CITY OF WEST LINN VALLEY VIEW DR AND SUNCREST DR STREET IMPROVEMENTS

PW-17-02

REVIEWED

By Morgan Palmer at 3:38 pm, Oct 24, 2018

V3.5

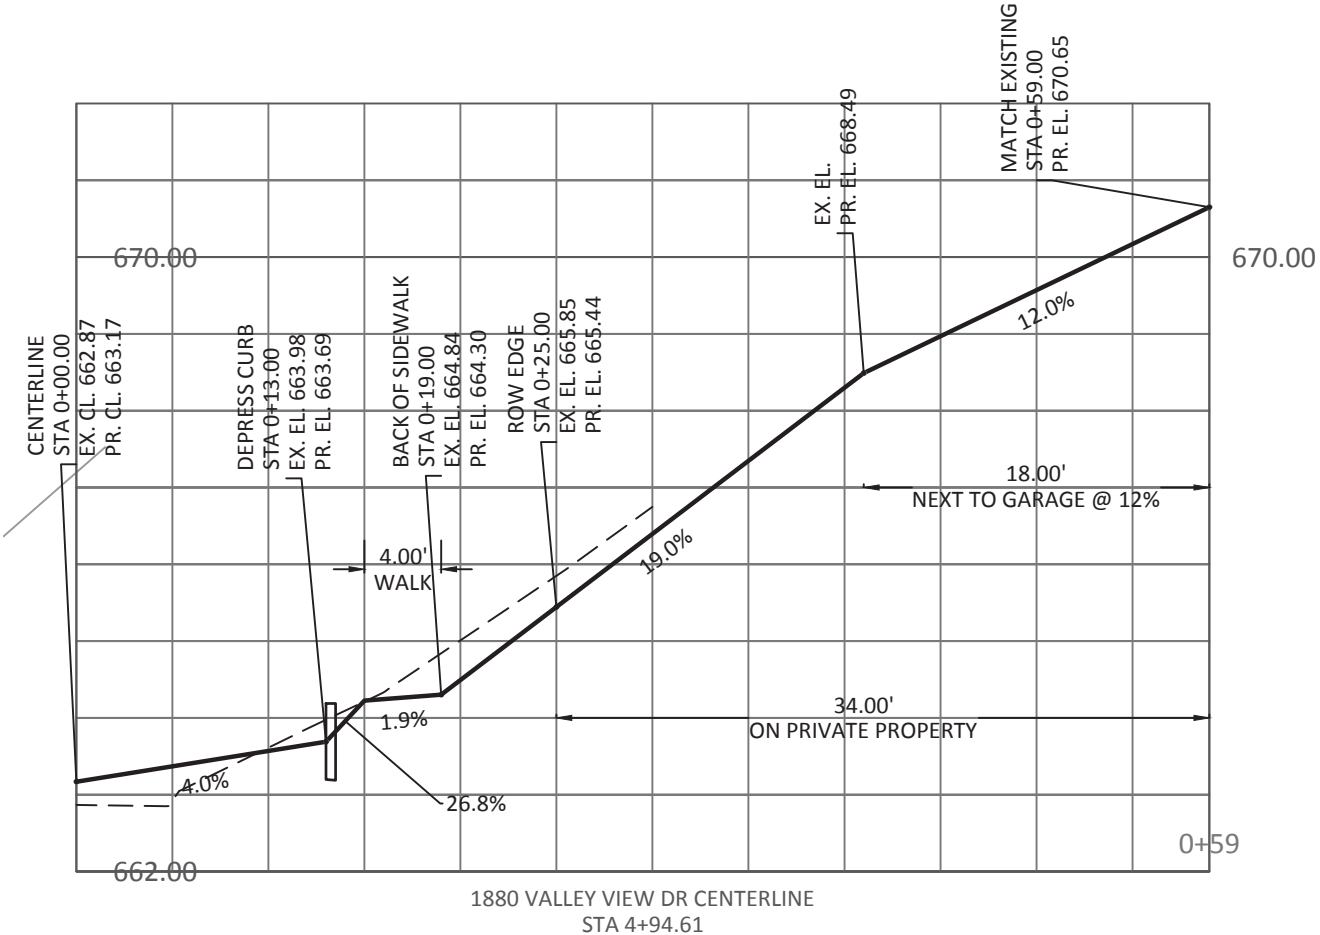
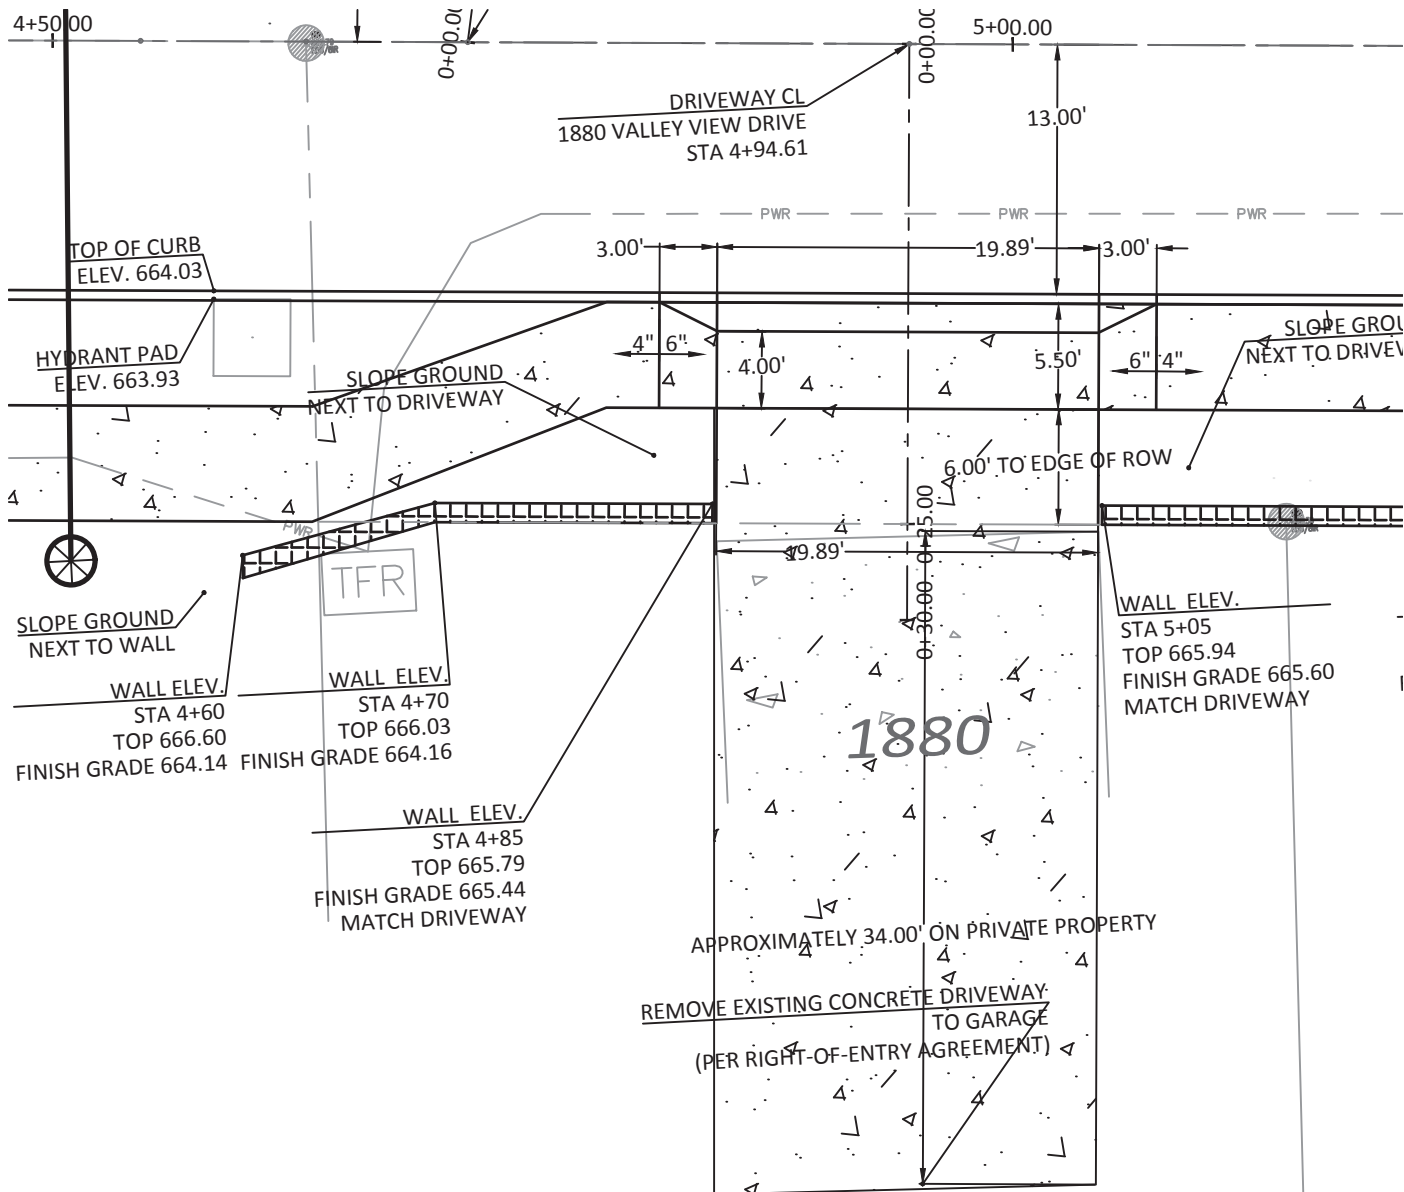
CONDUCT GRADING AND REPLACEMENT ACCORDING TO
RIGHT-OF-ENTRY AGREEMENT SIGNED ON 04/30/2018
(HOMEOWNERS HIRED THEIR OWN CONTRACTOR AND
CITY REIMBURSED THEM BASED ON UNIT COSTS)

V3.7

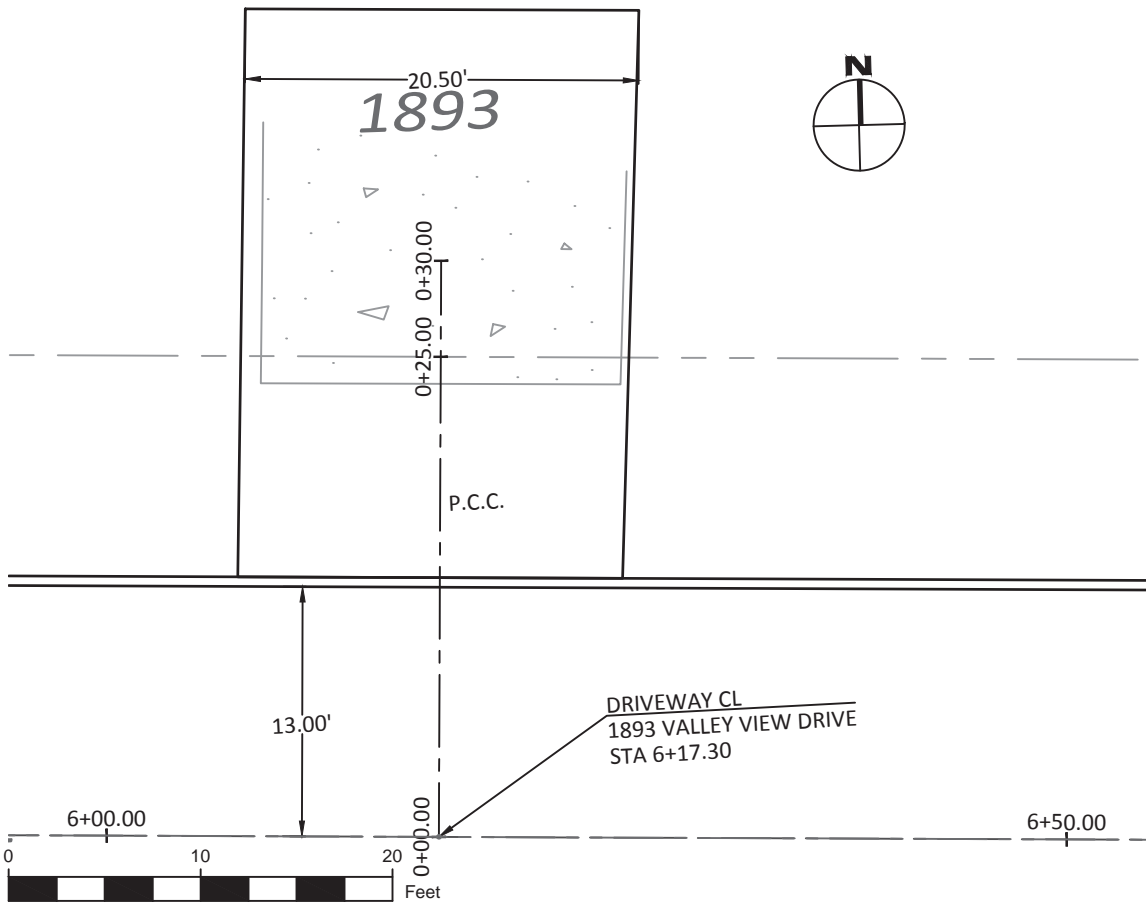
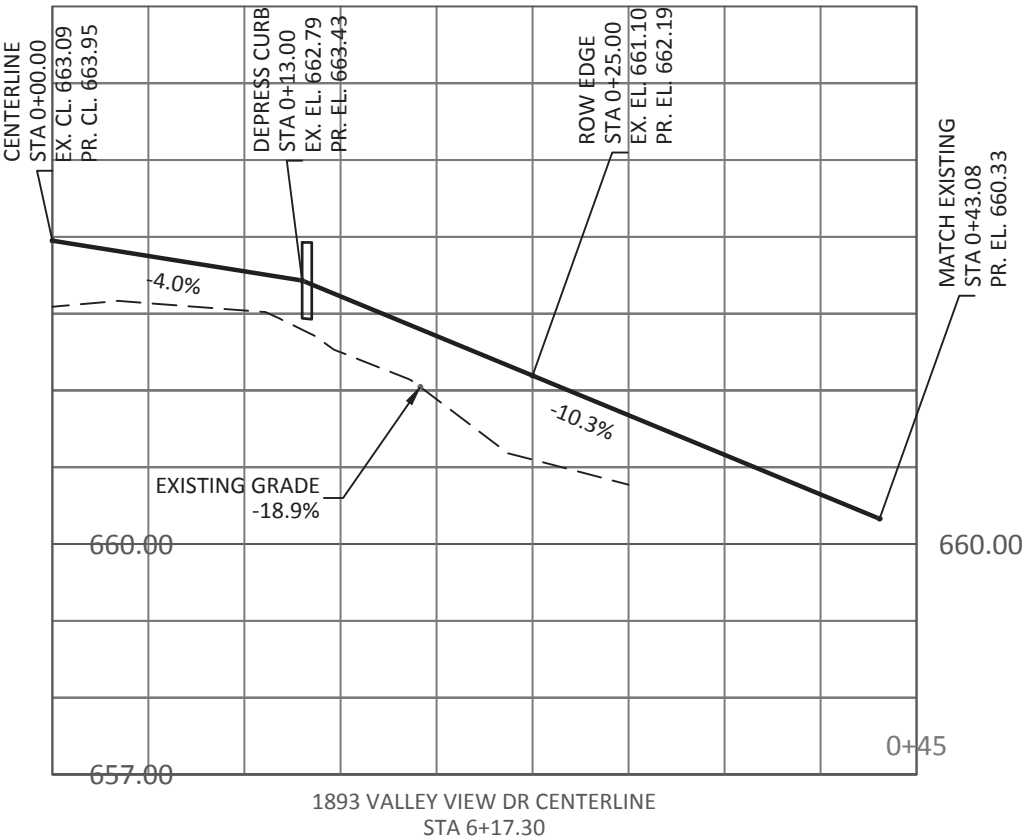
CONDUCT GRADING AND REPLACEMENT ACCORDING
RIGHT-OF-ENTRY AGREEMENT SIGNED ON 05/09/2018

HOMEOWNER TO PLACE DRAIN GRATE NEXT TO GARAGE
AFTER CONTRACTOR REMOVES EXISTING DRIVEWAY.

(COMPLETED UNDER A SEPARATE CONTRACT)

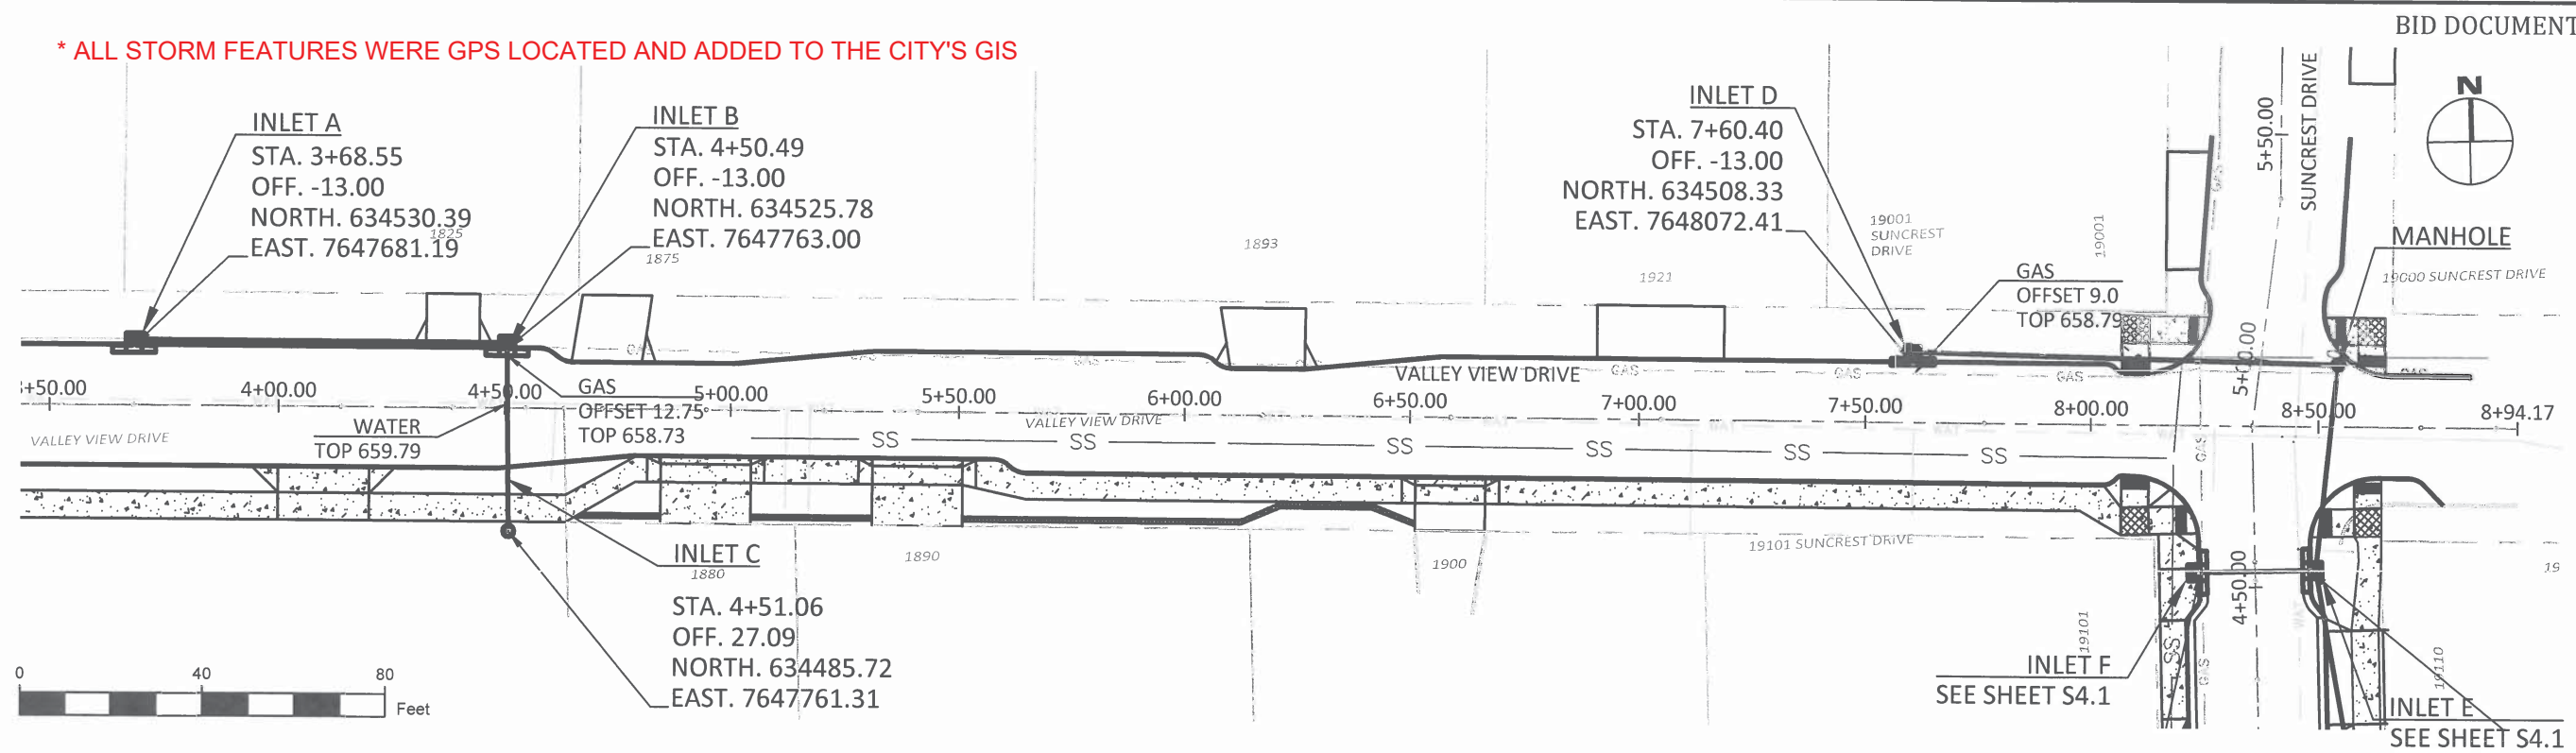
INLET A - CURB INLET (WL-600)
STA. 3+68.55
TOP OF CURB ELEV. ~~663.61~~ 663.69
INVERT ELEV. ~~659.20~~ (N) CONNECT EXISTING 12 INCH PIPE 658.31
INVERT ELEV. ~~659.20~~ (E) 659.51

MANHOLE
REPLACE EXISTING STORM CATCH BASIN WITH MANHOLE
STA. 8+54.25 (VALLEY VIEW ALIGNMENT), OFFSET 13.50' NORTH
RIM ELEV. ~~663.68~~ 663.04
INVERT ELEV. ~~659.23~~ (S) 659.32
INVERT ELEV. ~~659.57~~ (W) 659.79
INVERT ELEV. ~~659.10~~ (N) CONNECT EXISTING 12 INCH PIPE 659.36
INVERT ELEV. ~~659.30~~ (E) CONNECT EXISTING 12 INCH PIPE
THIS PIPE WAS ABANDONED BECAUSE IT DID NOT
CONNECT TO ANY EXISTING STORM INFRASTRUCTURE.
